**From:** [Harmon Rita T.](#)  
**To:** ["John Jacquez"](#)  
**Subject:** RE: Collete Park  
**Date:** Friday, October 23, 2015 10:32:31 AM

Please find the attached original grading and drainage plan and the revision (rfi 56). Due to existing utilities on site the invert of the sd pipe had to drop from 28 to 25.96. The previous design had a retaining wall, with the change in elevation we are now proposing a concrete slope blanket and the pipe mitered to the slope instead of the retaining wall.

# COLLET PARK ELEMENTARY ADDITIONS & RENOVATIONS ALBUQUERQUE PUBLIC SCHOOLS

GRADING AND DRAINAGE PLAN  
project no. 08-007

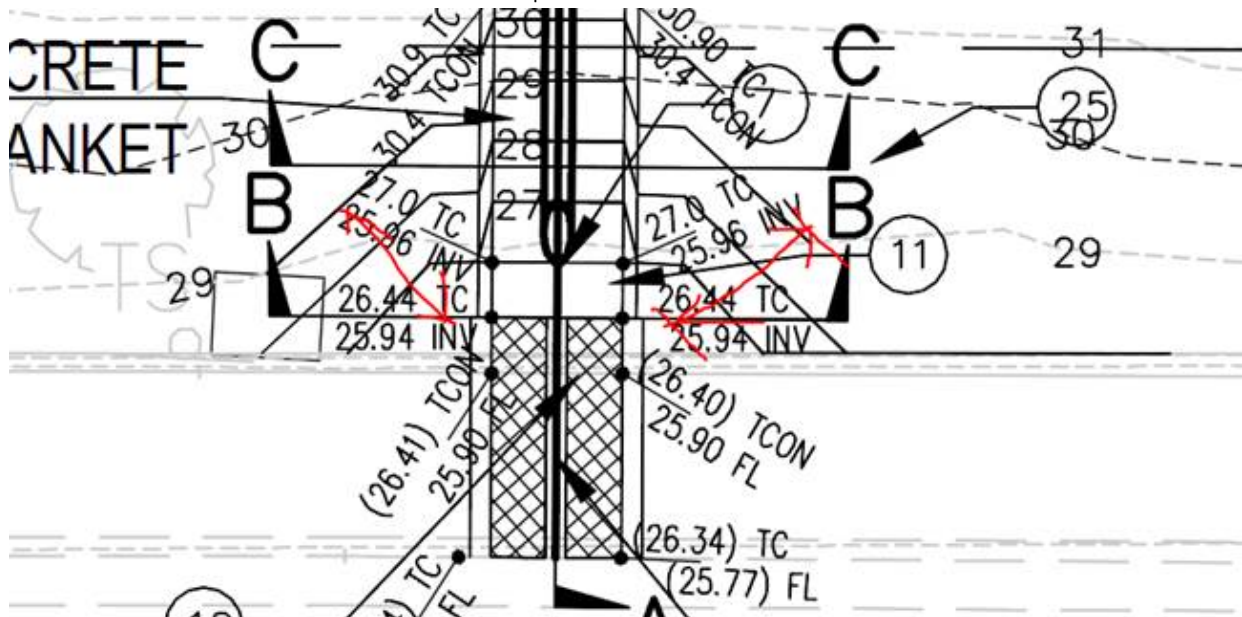
2.5:1 is the best I could do without having a wall over 12" tall. Remember that there is an existing wall that runs behind the sidewalk parallel to the sidewalk. These improvements are all behind the existing wall. The existing wall is about 18" to 24" tall. Look on google earth.

John,  
I can't scale the electronic. What is the slope here?

**C-101A**

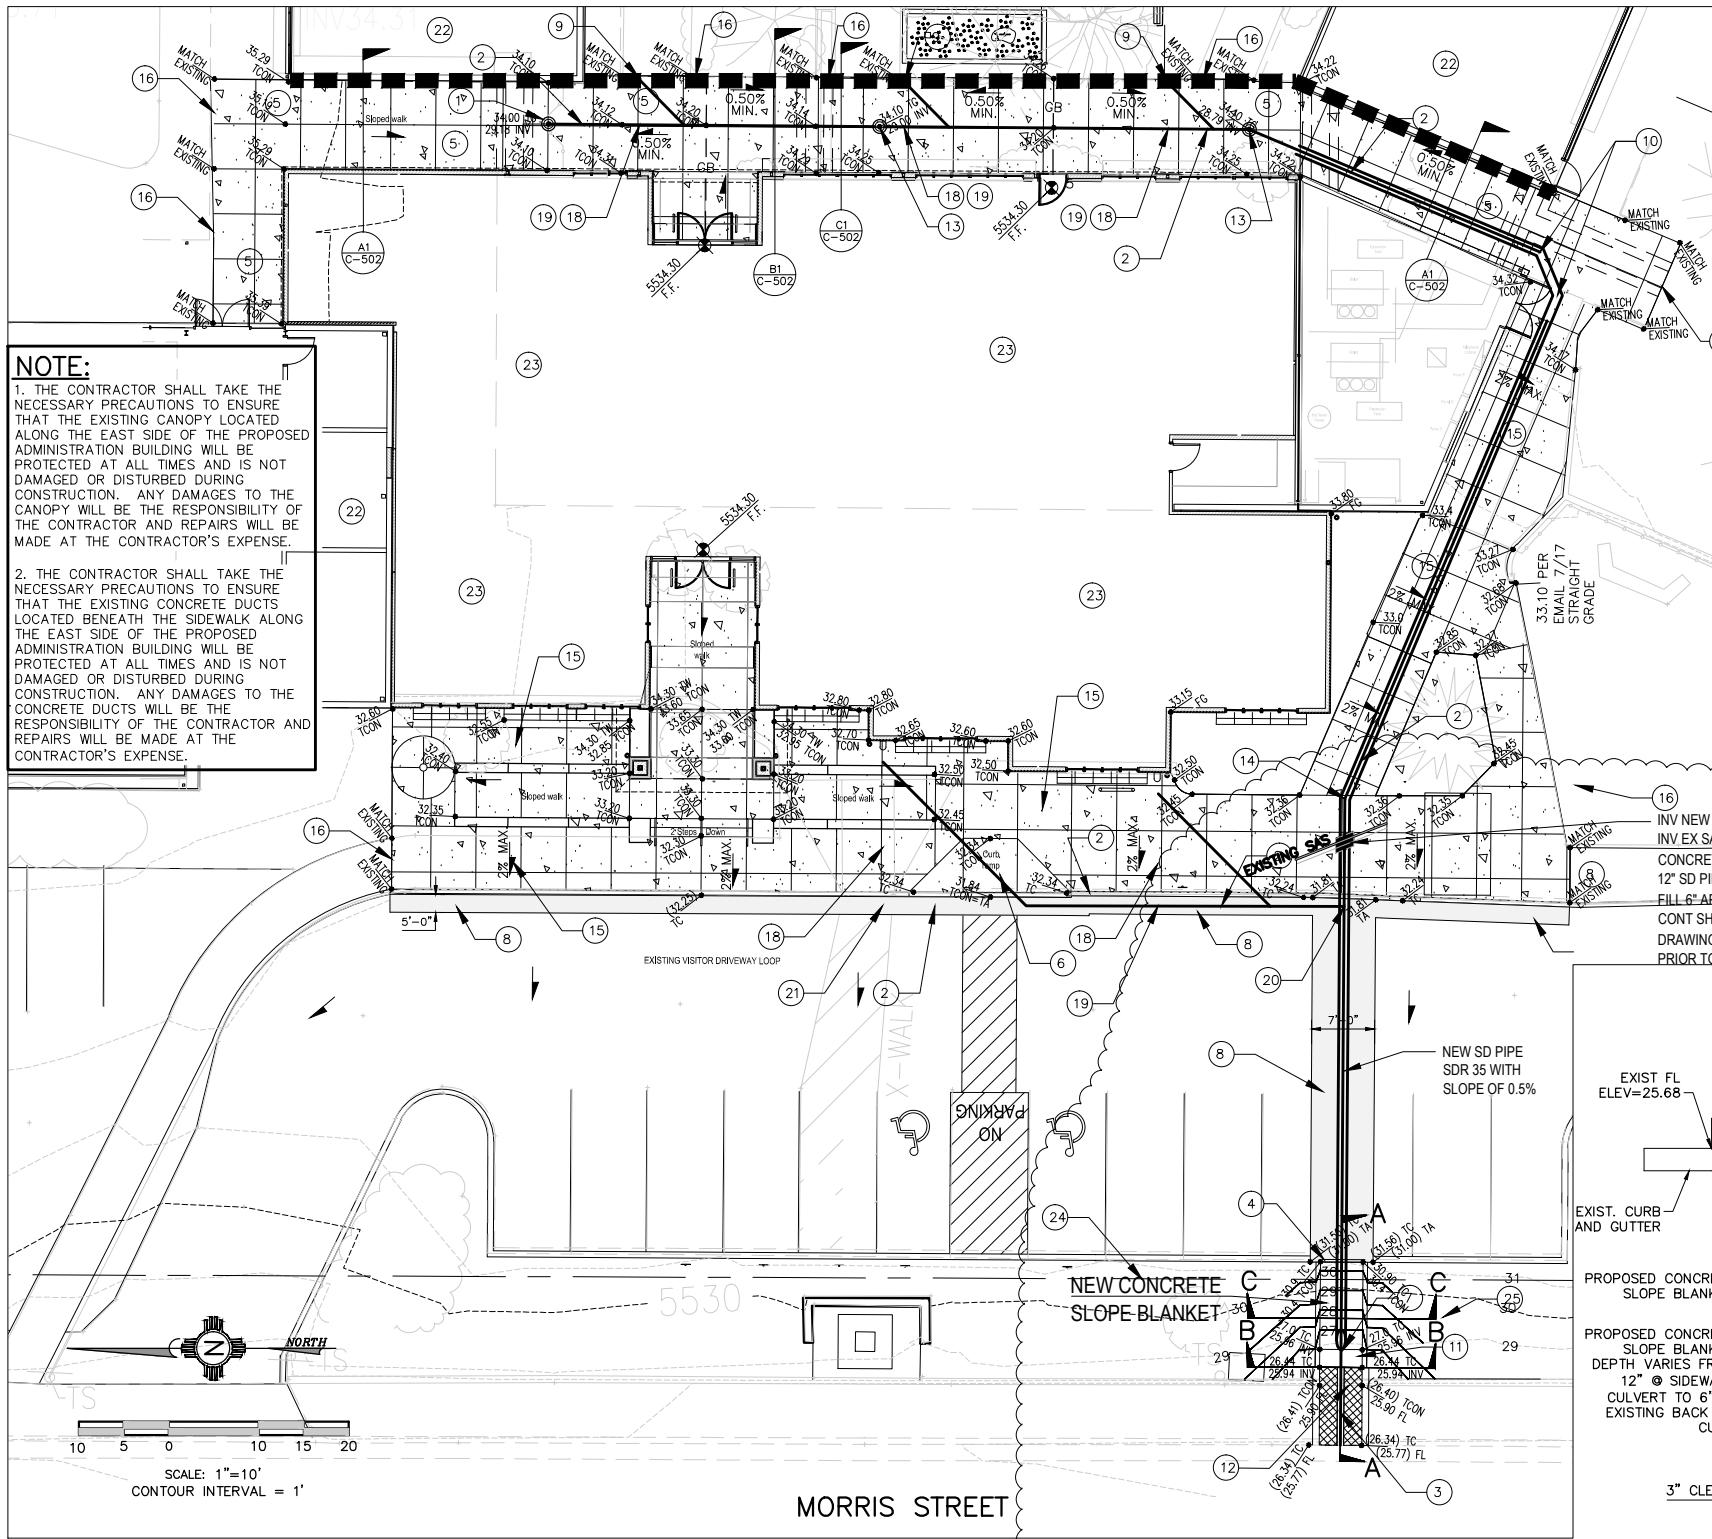
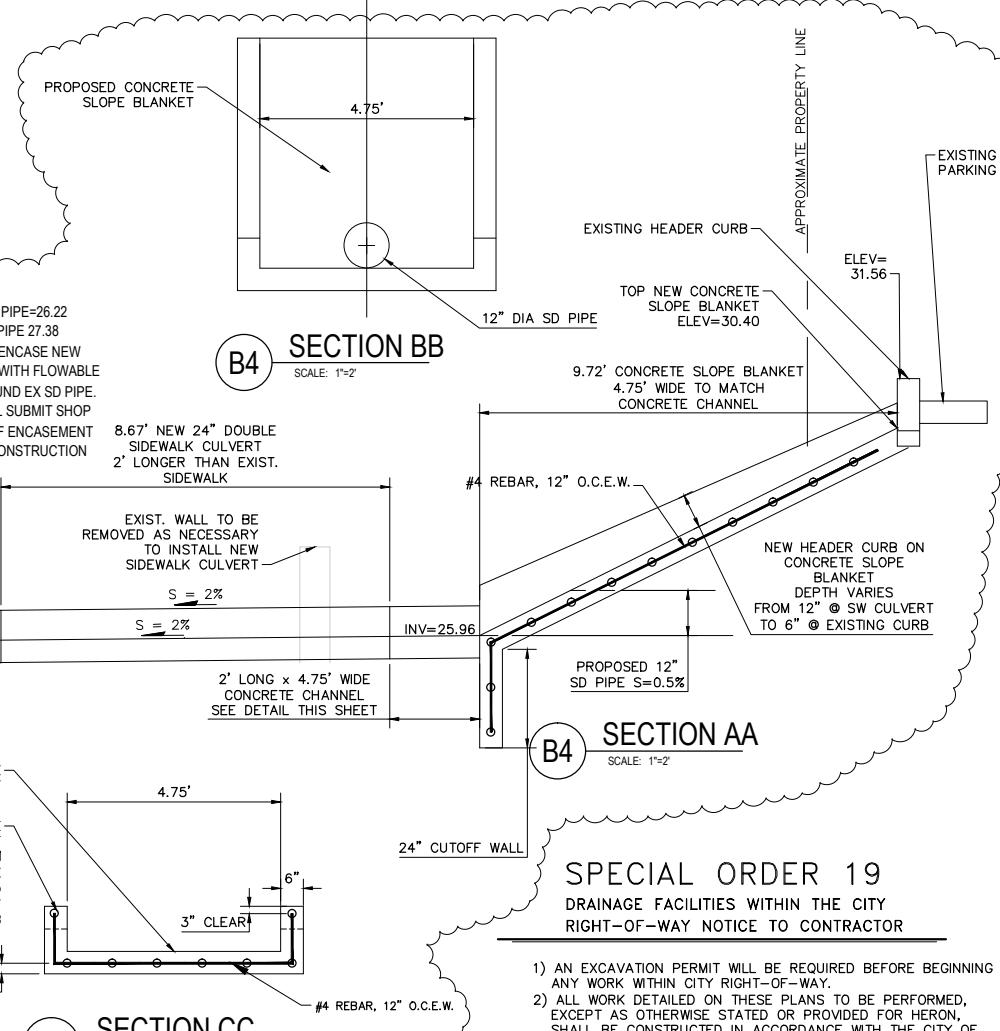
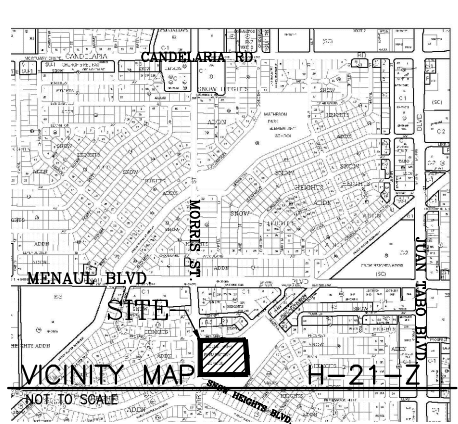
We are hoping to as built this and show it on the as built certification, but since there is an SO-19 the inspector may say something due to the change from the originally approved Grading and Drainage Plan.

John, Verlyn.  
I am ok with the revisions. When you submit the Engineer's Certification plan, submit the Approved plans as well as this revised plan. Put a bubble around the area in the plan view that has changed and show all the as-built information on the revised plan. I will include this correspondence in the drainage file.
